Re: Comments on the Draft Biological Goals and Objectives for the Desert Renewable Energy Conservation Plan (DRECP) dated March 21, 2012.

Date:	March 21, 2012
To:	Dave Harlow, Director of the DRECP Scott Flint, DRECP Program Manager, California Energy Commission DRECP Stakeholder Committee
Cc:	Renewable Energy Action Team (REAT)
From:	ICF International, Dudek
Subject:	DRAFT Revised DRECP Biological Goals and Objectives

Figure 2. Integration of DRECP Biological Goals with the Plan-wide Reserve Design Process

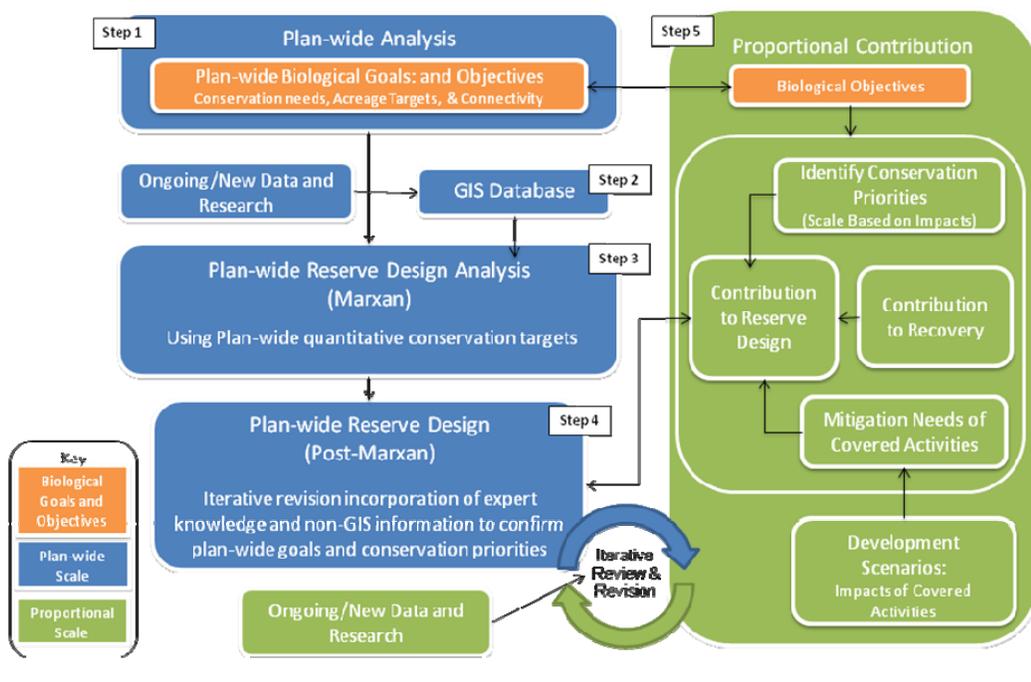
Comment [11]: As discussed at the workshop, we have strong concerns over the “proportional contribution” of the plan in its ability to provide assurances for conservation. This issue is a key component to the success or failure of the plan and needs additional discussion.
